Access Compliance Report

Public Rights-of-Way

(Curb Ramps)

Intersection ID: 12760	Main Street: N_MYERS_ST	Cross Street: E_7TH_ST	Location: S
ADA ID: 4622F3D12605	Ramp Type: PerpDiag	Initial Pass/Fail: Fail	Overall Compliance: No
		Severity Score: 25

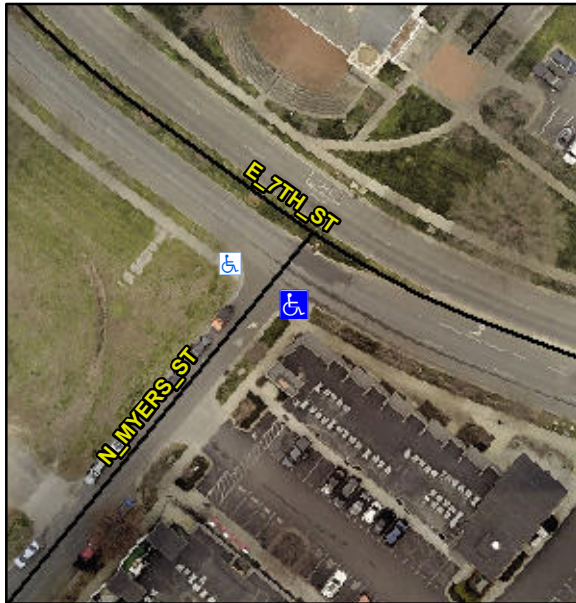
Not Found, R304.5.1, R304.5.3, R302.7

Compliance	Description	Data	Compliance	Description	Data
N/A	Ramp Length (in)	94.0	Yes	Ramp Slope (%)	5.7
No	Ramp Width (in)	47.0	No	Ramp XSlope (%)	2.1
N/A	Flare Type LT	N/A	N/A	Flare Type RT	N/A
N/A	Flare Slope LT (%)	N/A	N/A	Flare Slope RT (%)	N/A
N/A	Flare Traversable LT?	N/A	N/A	Flare Traversable RT?	N/A
N/A	Landing Length (in)	N/A	N/A	DWS Provided?	N/A
N/A	Landing Width (in)	N/A	N/A	DWS Contrast?	N/A
N/A	Landing Slope (%)	N/A	N/A	DWS Length (in)	N/A
N/A	Landing X Slope (%)	N/A	N/A	DWS Full Width?	N/A
N/A	Landing Curb? (Y/N)	N/A	N/A	DWS Offset (in)	N/A
N/A	Shared Landing?	N/A			
N/A	Gutter Ponding?	N/A	N/A	Gutter Slope (%)	N/A
N/A	Gutter Lip Ht (in)	N/A	N/A	Gutter X Slope (%)	N/A
N/A	Painted X Walk1?	No	N/A	Painted X Walk2?	No
	X Walk 1 Direction	To NE		X Walk 2 Direction	To NW
N/A	X Walk 1 Width (in)	N/A	N/A	X Walk 2 Width (in)	N/A
	X Walk 1 Slope (%)	0.9		X Walk 2 Slope (%)	5.1
	X Walk 1 X Slope (%)	1.9		X Walk 2 X Slope (%)	3.4

N/A	Ramp inside XWalk1?	N/A	N/A	Ramp inside XWalk2?	N/A
	Road Slope (%)	2.1	N/A	Clear Space?	N/A
	Road X Slope (%)	4.8	N/A	Clear Space to XWalk (in)	N/A
N/A	Any Obstructions?	N/A	N/A	Storm Grate/Utility Hazard?	N/A
	Obstruction Type			Storm Grate/Utility Type	
		N/A			N/A
		No		Surface Condition? (G/P)	Poor

Remove & Replace Curb Ramp With Two New Directional Ramps or Equivalent.
